A D D E N D U M

Project: EACS HS Classroom Renovations

Addendum No: 02

Date: 12-18-2024

- ALL CASEWORK SHALL COMPLY WITH THE FOLLOWING REQUIREMENTS UNLESS NOTED OTHERWISE.
- WALL CABINETS SHALL BE 12" DEEP.
- BASE CABINETS SHALL BE 24" DEEP.

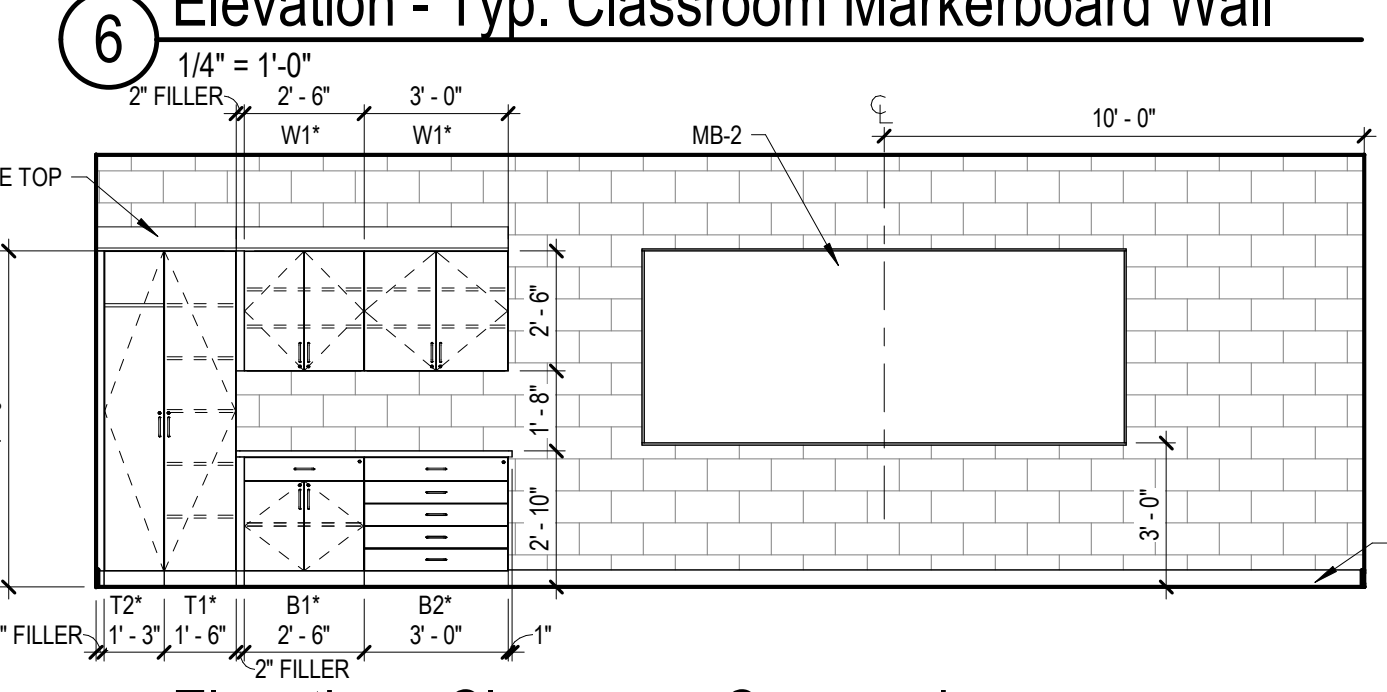
ITEM NO. 2.03 - DRAWING NO. A-141 Finishes Plan – Second Floor

- A. Revision to Elevation - Typ. Classroom Casework #2
- B. Revision to Elevation - Classroom Instruction Wall #4

Architectural Demolition
 Plan - Second Floor

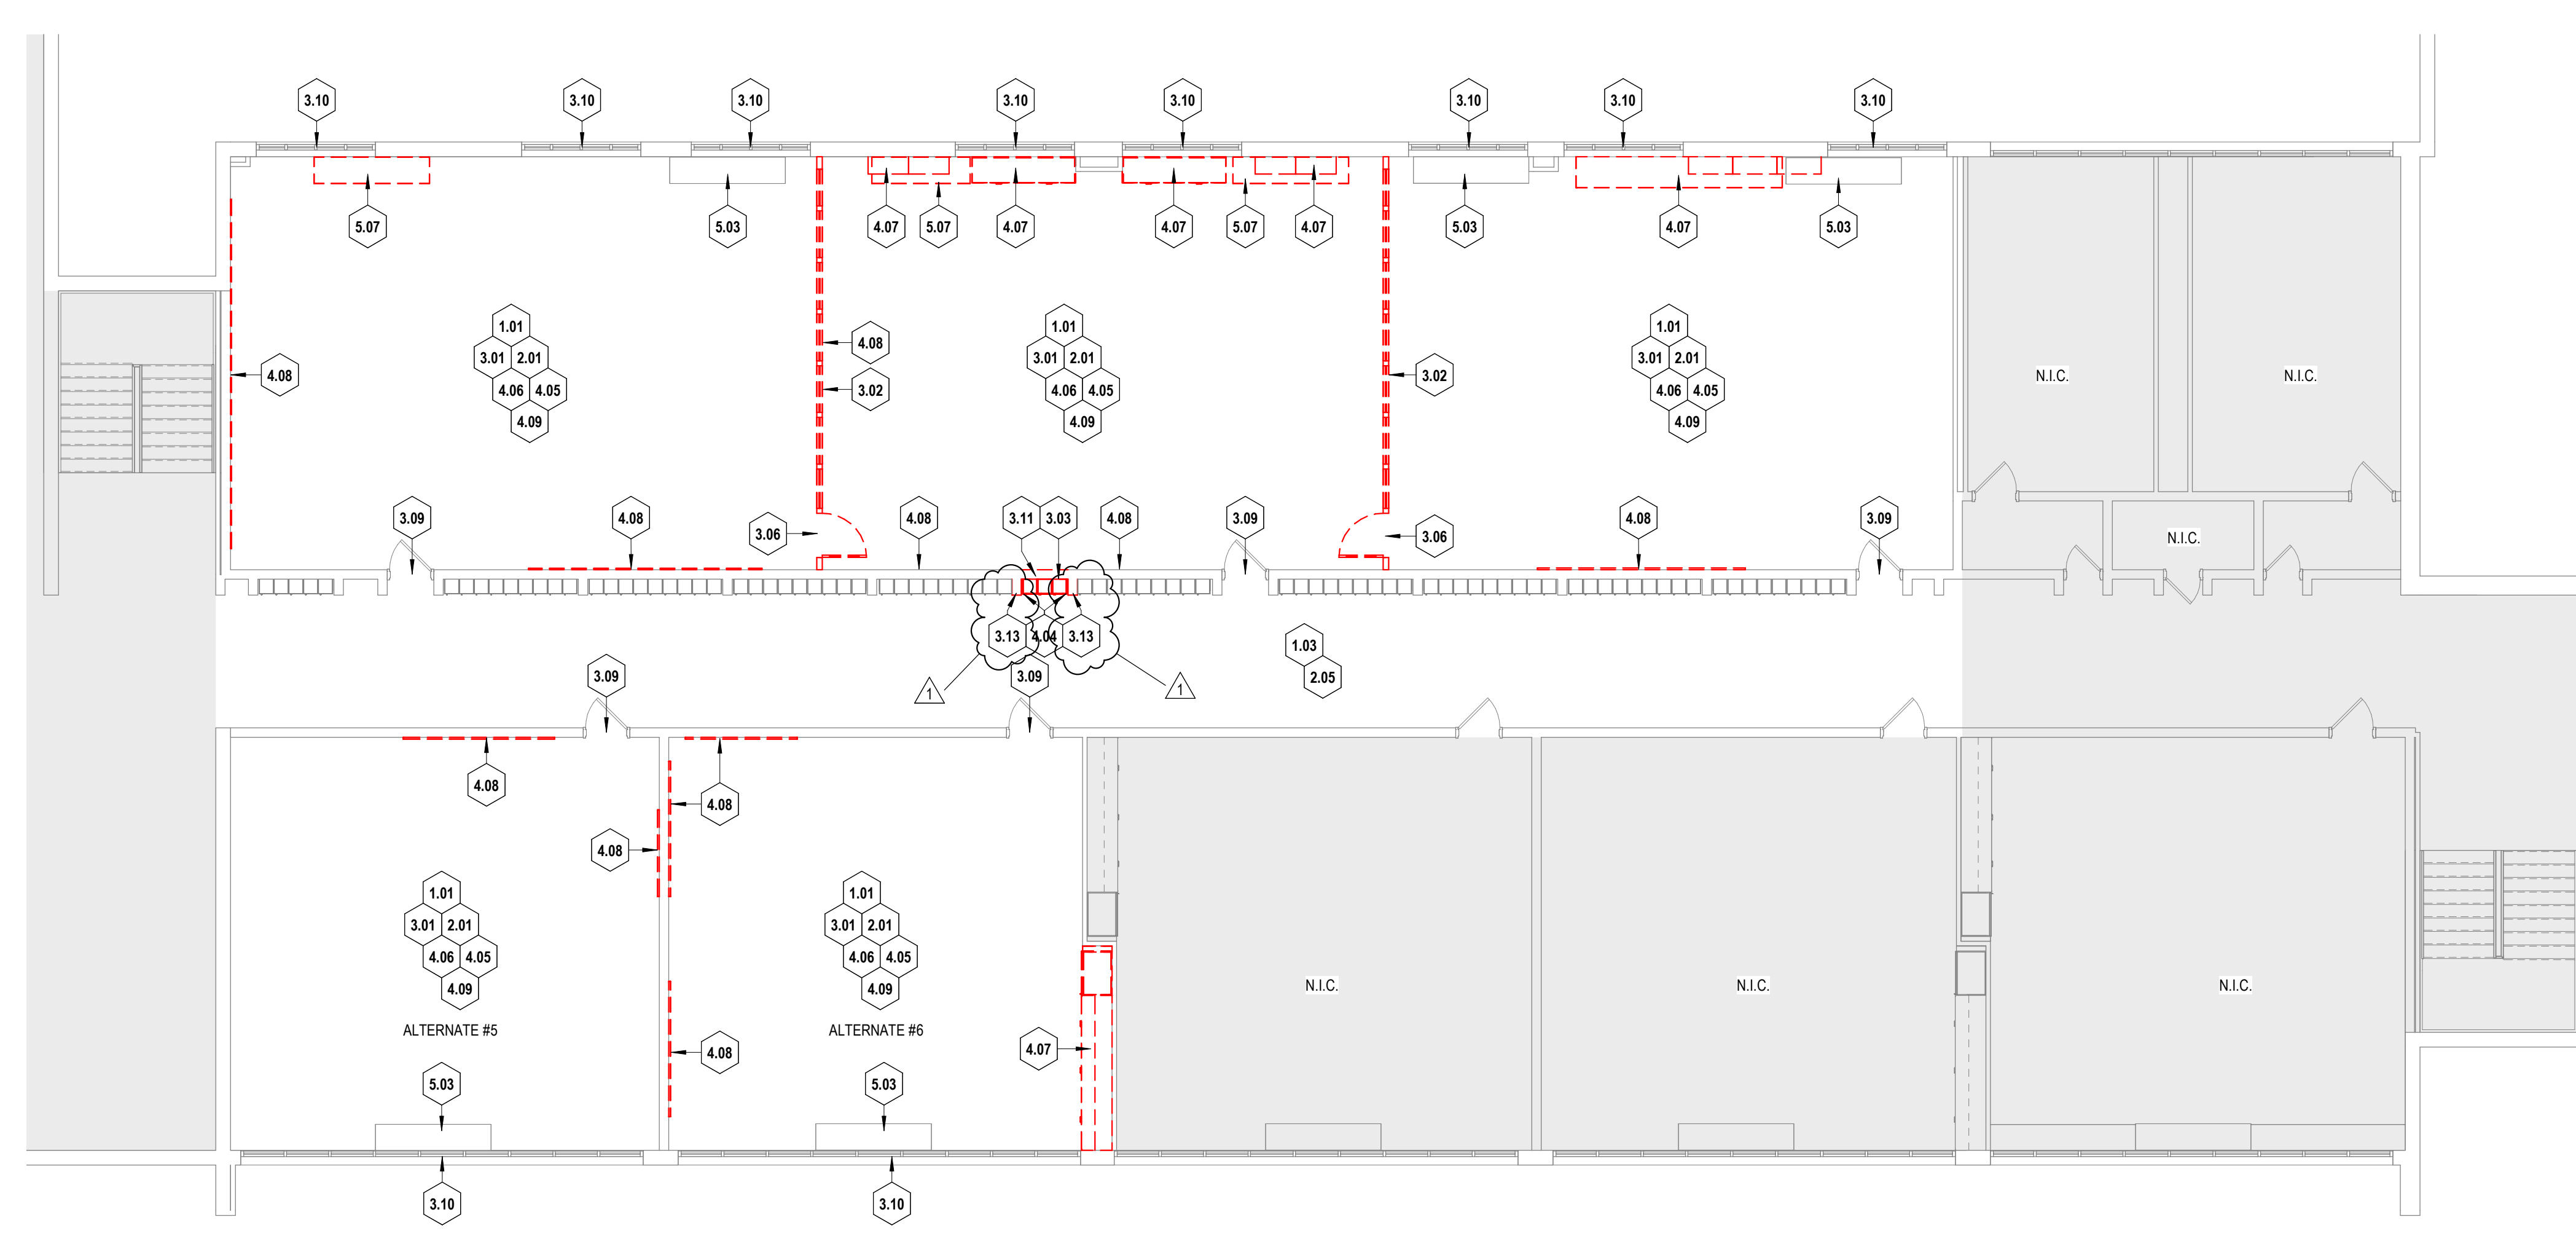
ITEM NO. 2.04 - DRAWING NO. AD101 Architectural Demolition Plan – Second Floor In response to RFI #B-03

- A. Addition of note 3.13 to Demolition Plan Notes.
- B. Addition of Demolition Plan Note 3.13 to Hallway 200.

3.11	REMOVE PARTITION OF WALL PARTITION CONSTRUCTION OF NEW OPENING AS REQUIRED.
3.13	REMOVE PARTITION IN ITS ENTIRETY INCLUDING WALL COVERINGS, WALL BASES, AND ANY DOORS/DOOR FRAMES WITHIN.
EXTERIOR DEMOLITION

Architectural Notation Plan - Second Floor

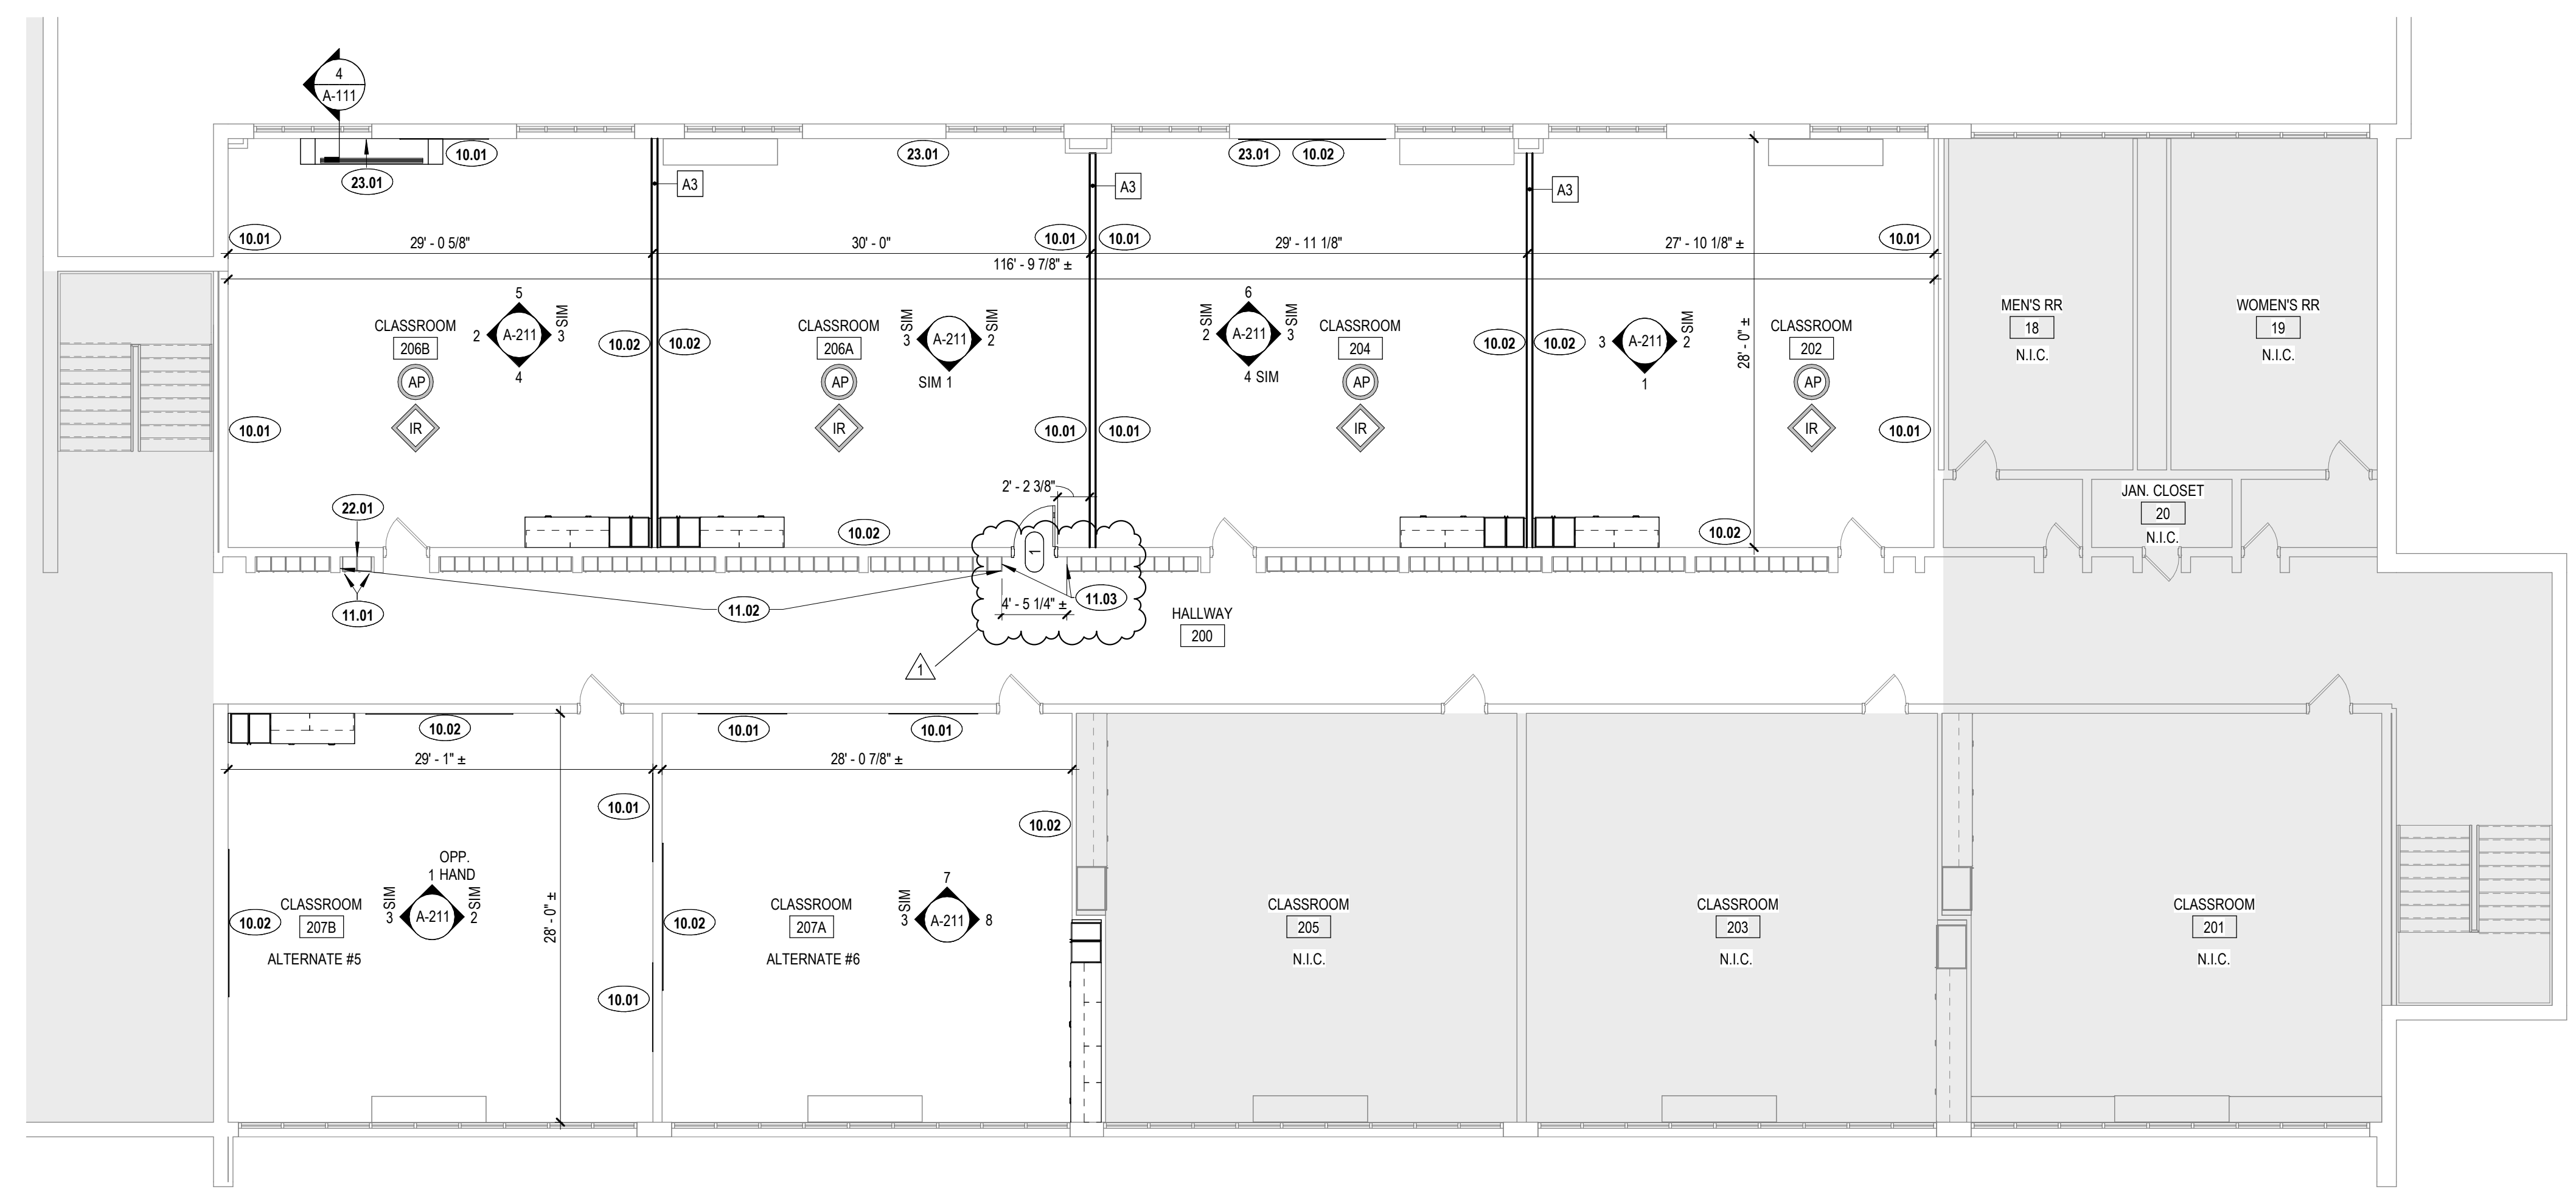
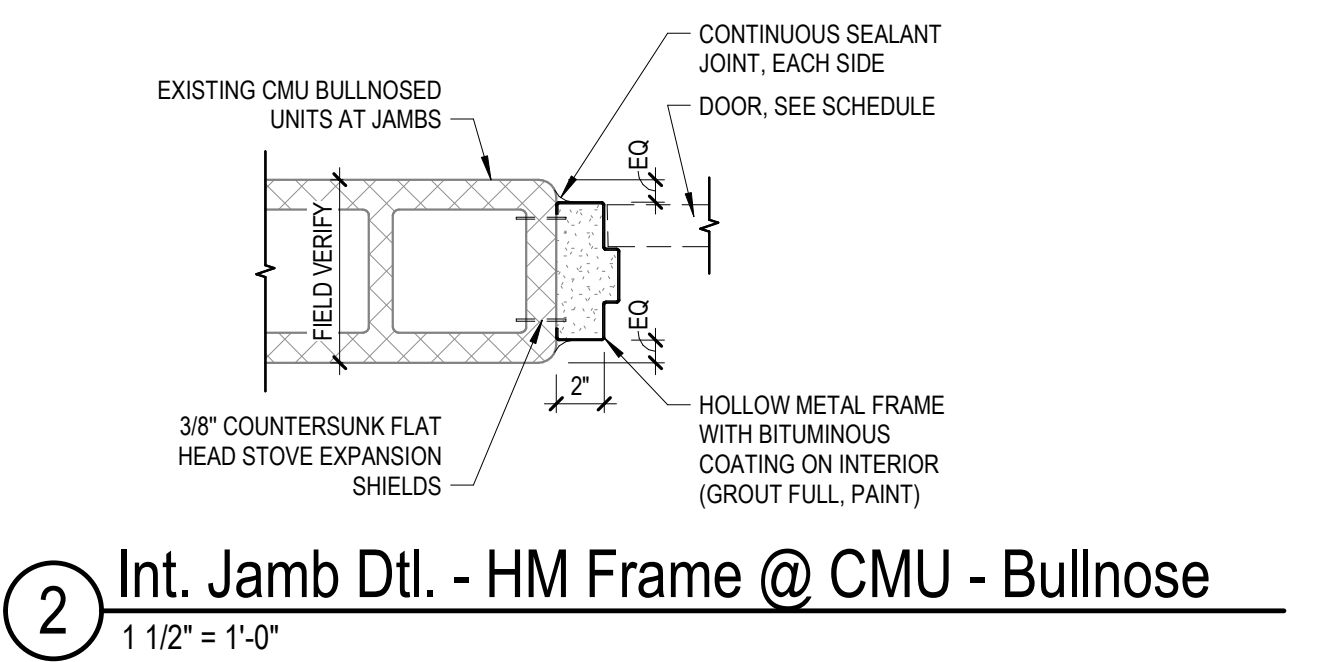
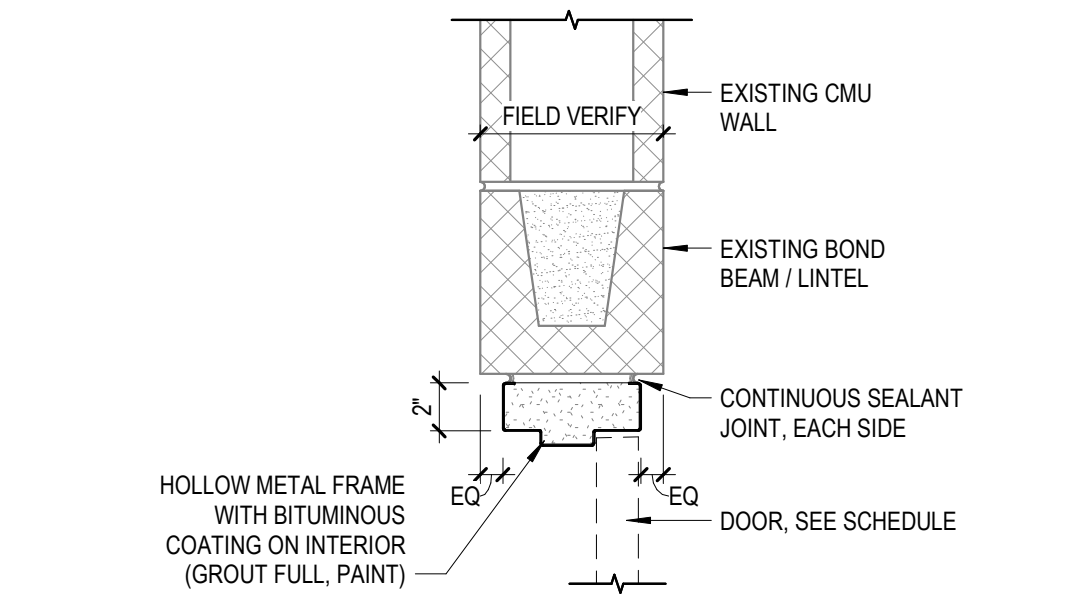
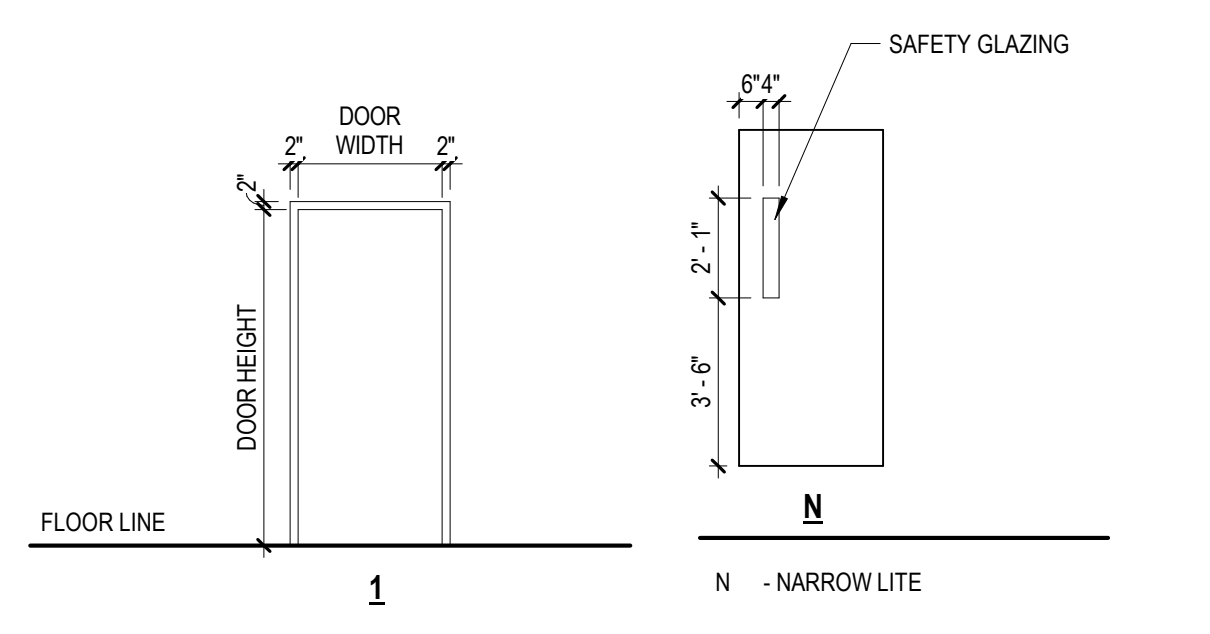
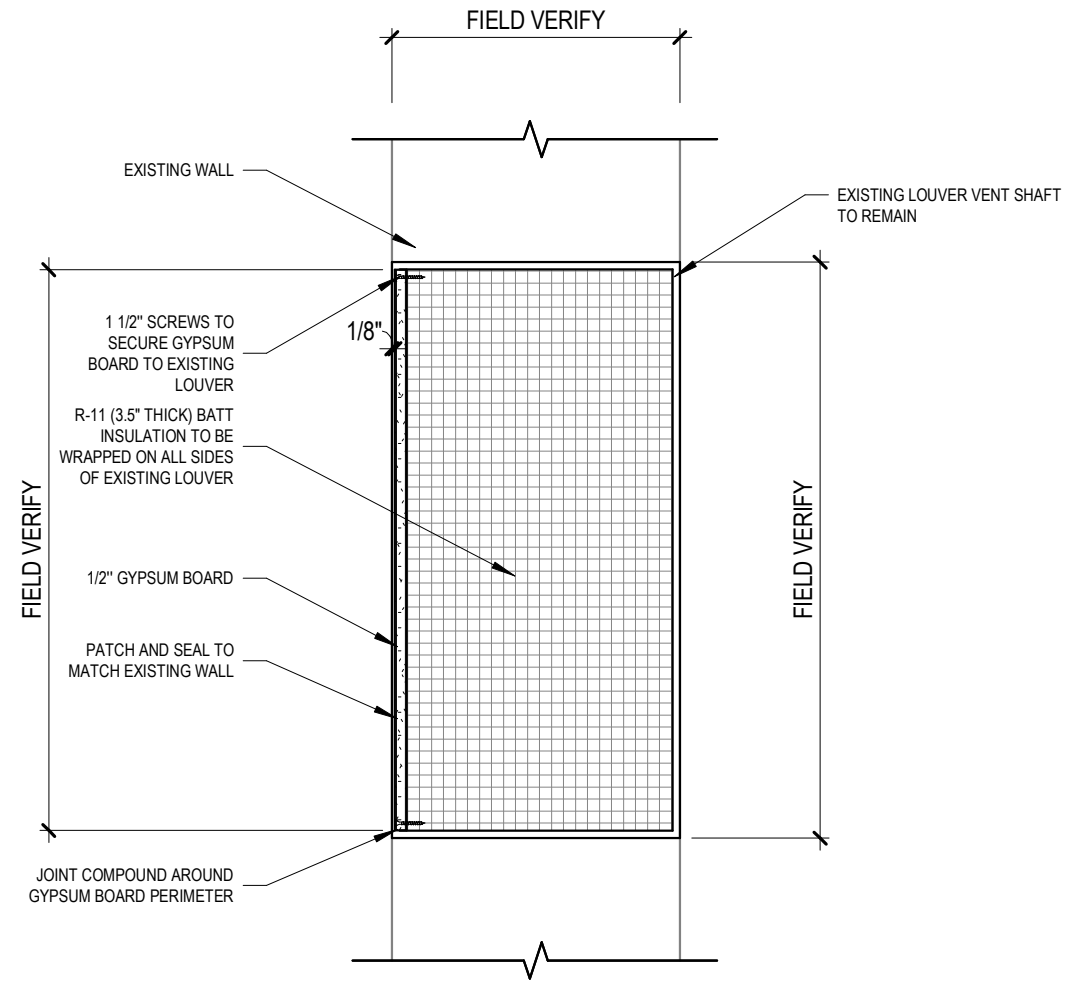
ITEM NO. 2.05 - DRAWING NO. A-111 Architectural Notation Plan – Second Floor In response to RFI #B-03

- A. Addition of note 11.03 to Floor Plan Notes.
- B. Addition of Floor Plan Note 11.03 to Second Floor Architectural Notation Plan
